**DATE:** 10.30.2019  
**TO:** ProTrak  
**FROM:** Mitesh Baxi  
Traffic Engineering

■ **CROSSROADS INFINITI [TRC Plan Review]**

↻ Initial Review Note ↻

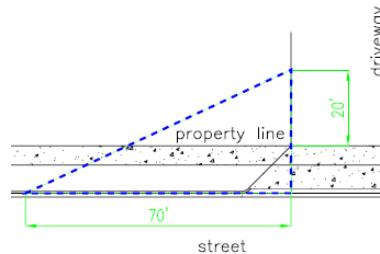
- Install wheelchair ramp at both the corners of proposed street type driveway per NCDOT and/or City standards. Connect sidewalk with ramp.
